Technical Service Bulletin: TSB150057	Released Date: 17-May-2019
Aftertreatment Outlet NOx Sensor Water Intrusion Resulting in Fault Code 1887, 3583, or 3545

Aftertreatment Outlet NOx Sensor Water Intrusion Resulting in Fault Code 1887, 3583, or 3545

Figure 1, Two Outlet Nox Sensor Bolt-In Water Shield Bolts in the Exhaust Pipe.

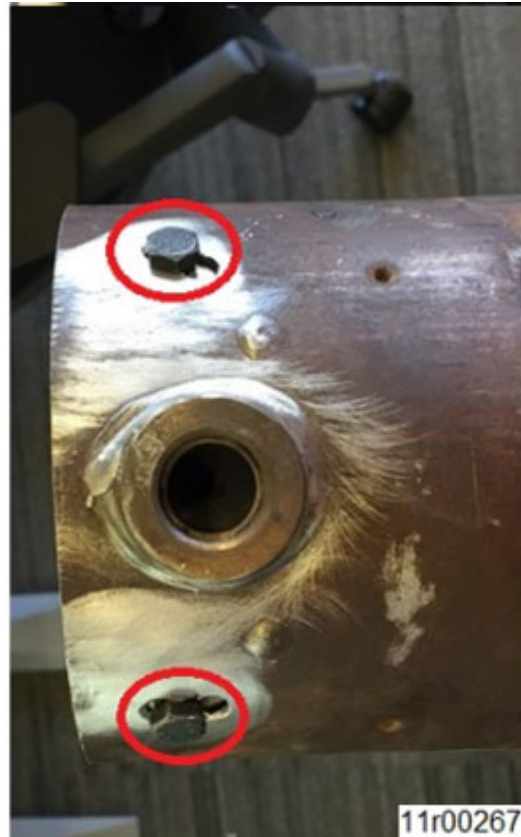
To assess if a unit already has an outlet NOx sensor bolt-in water shield installed:

- Inspect for spot welds or two bolts installed in the tailpipe near the outlet NOx sensor. See Figure 1 below.
- Verify the build of the engine serial number (ESN) is August 2015 or later. This can be done using the physical engine dataplate or QuickServe® Online dataplate.

If symptom has been verified, the aftertreatment outlet NOx sensor bolt-in water shield **must** be installed. See Installation Instructions 4908441, for details on how to install the aftertreatment outlet NOx sensor bolt-in water shield.
